Access Compliance Report Public Rights-of-Way (Curb Ramps)

Main Street: SALIENTE_RD Cross Street: CANTAR_ST Location: NW

ADA ID: RPAT211104095235 Ramp Type: Type 4 - Parallel Initial Pass/Fail: Fail Overall Compliance: No Severity Score: 32

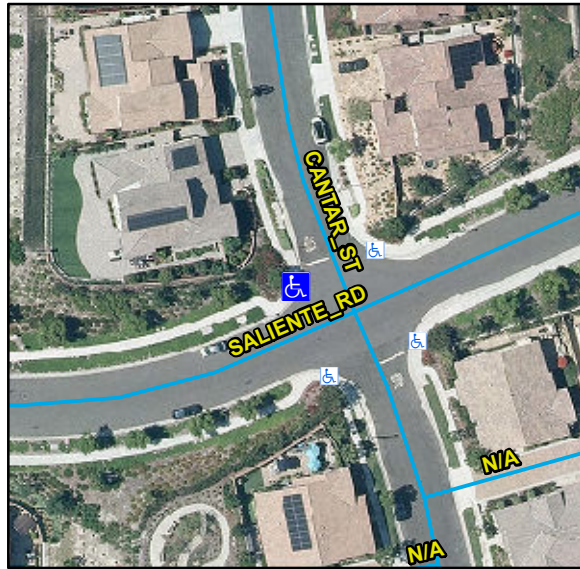
Compliance	Description	Data	Compliance	Description	Data
N/A	Ramp Length LT (in)	101	N/A	Ramp Length RT (in)	108
Yes	Ramp Width LT (in)	54	Yes	Ramp Width RT (in)	54
Yes	Ramp Run Slope LT (%)	4.9	No	Ramp Run Slope RT (%)	14.3
Yes	Ramp Cross Slope LT (%)	0.5	No	Ramp Cross Slope RT (%)	2.1
N/A	Landing Present	N/A	N/A	DWS Provided	N/A
N/A	Landing Length (in)	N/A	N/A	DWS Contrast	N/A
N/A	Landing Width (in)	N/A	N/A	DWS Length (in)	N/A
N/A	Landing Run Slope (%)	N/A	N/A	DWS Full Width	N/A
N/A	Landing Cross Slope (%)	N/A		DWS Offset Type	N/A
N/A	Landing Movement Obstructed?	N/A	N/A	DWS Offset Left (in)	N/A
	Landing Movement Type	N/A	N/A	DWS Offset Right (in)	N/A
N/A	Landing Shared	N/A			
N/A	Clear Space	Yes			
N/A	Clear Space To Crosswalk (in)	N/A			
N/A	Marked Crosswalk 1	No	N/A	Marked Crosswalk 2	No
	Crossing 1 Direction	S		Crossing 2 Direction	E
	Marked Crosswalk 1 Width (in)	N/A		Marked Crosswalk 2 Width (in)	N/A

N/A	Ramp Inside Crosswalk 1	N/A	N/A	Ramp Inside Crosswalk 2	N/A
	Crossing 1 Slope (%)	0.6		Crossing 2 Slope (%)	7.3
	Crossing 1 Cross Slope (%)	8.5		Crossing 2 Cross Slope (%)	3
N/A	Gutter Ponding	N/A	N/A	Curb Slope	7.7
Yes	Gutter Lip Height (in)	0		Road Run Slope (%)	6.6
N/A	Gutter Run Slope (%)	N/A		Road Cross Slope (%)	6
N/A	Gutter Cross Slope (%)	N/A	Yes	Perpendicular Joint Present	Yes
Yes	Overall Surface Condition	Acceptable			
	Cross Gutter Present?	No		Spandrel Present?	No
	Replace Cross Gutter?	N/A		Replace Spandrel?	N/A

Remove & Replace Curb Ramp With Two New Directional Ramps or Equivalent.
